## Product Change Notice

Issue Date: 26-May-2021

New dice replacement for Surface Mount Display

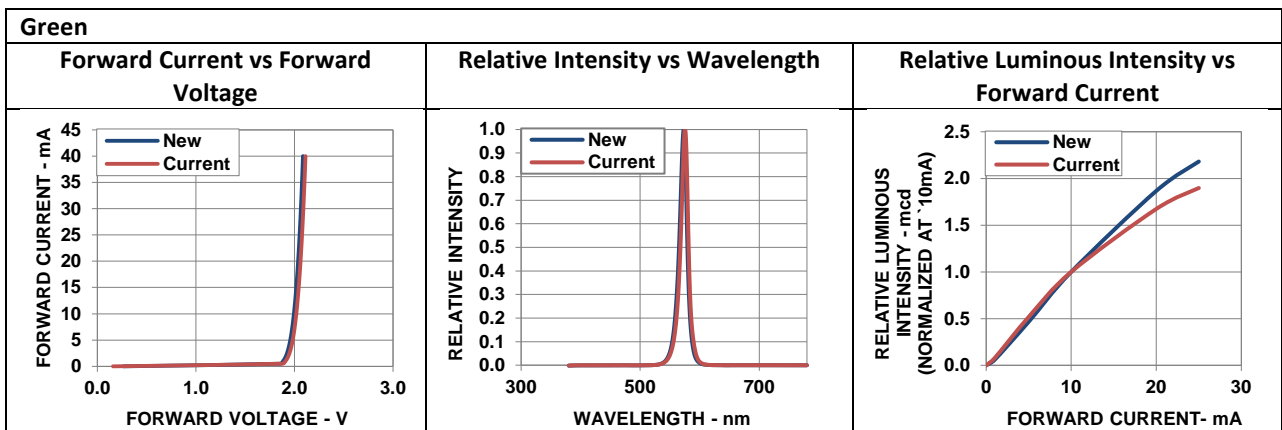
Following are changes in product characteristic:

1. Forward Voltage vs Forward Current
2. Relative Intensity vs Wavelength
3. Relative Intensity vs Forward Current

Part	Current (bottom view)	New (bottom view)
HDSM-281C		
HDSM-283C		
HDSM-291C		
HDSM-293C

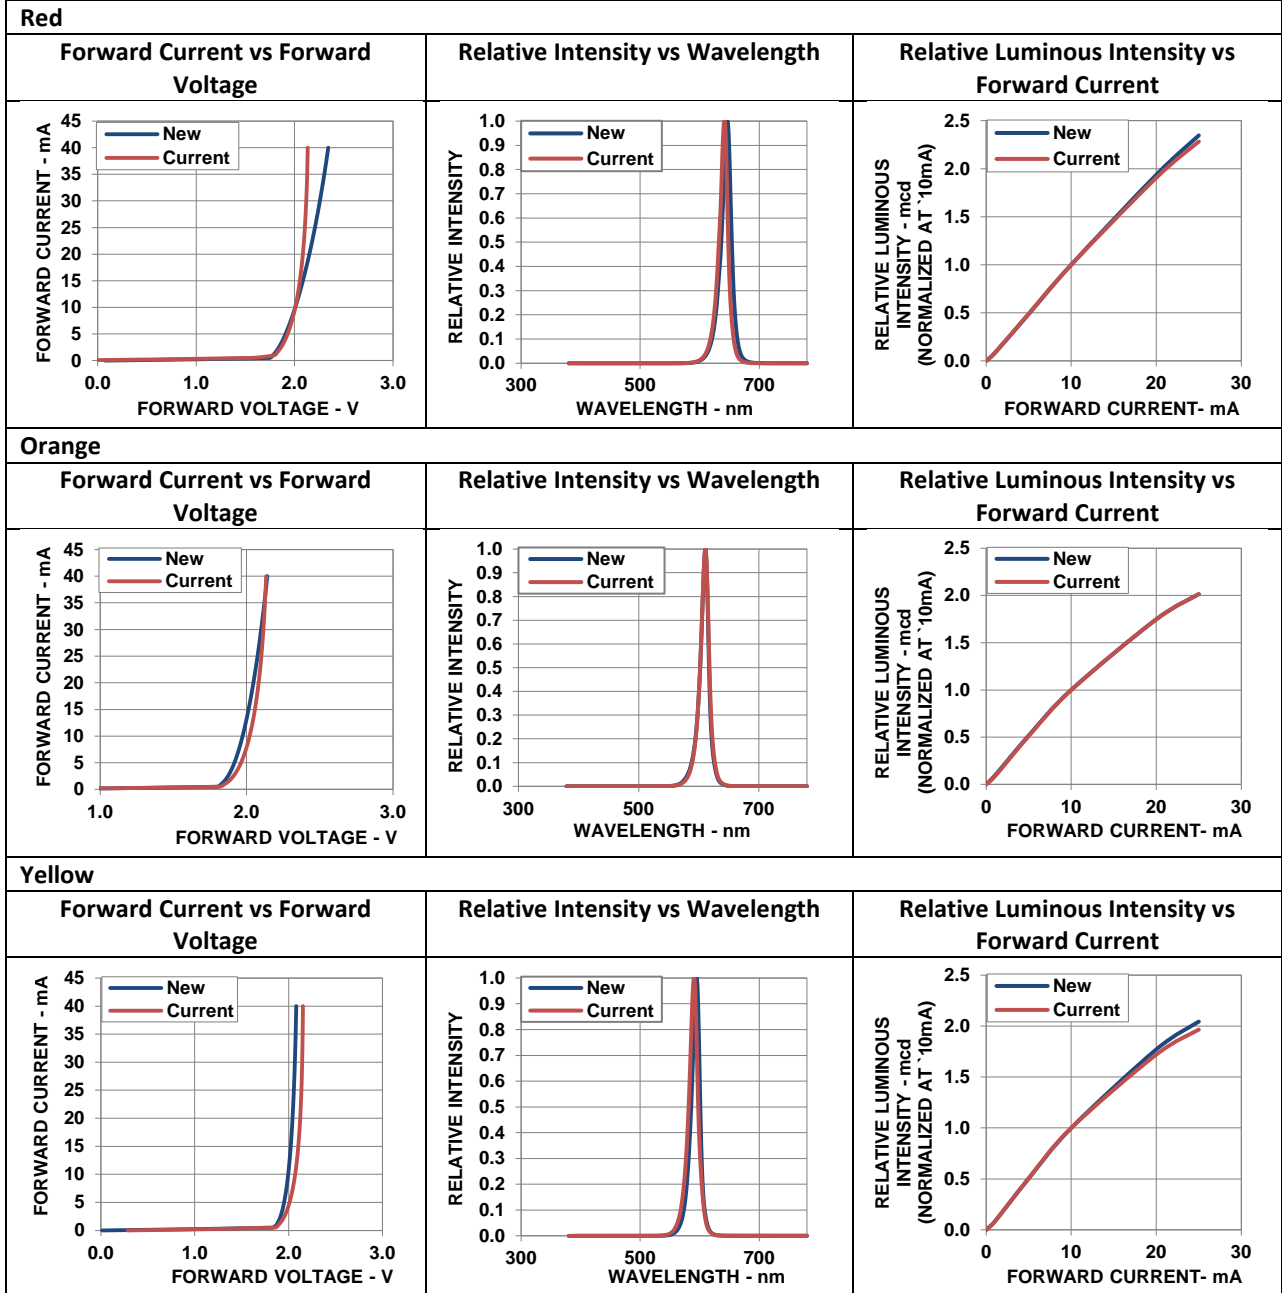
For HDSM-28xC & HDSM-29xC, there is PCB layout change as illustrated below:
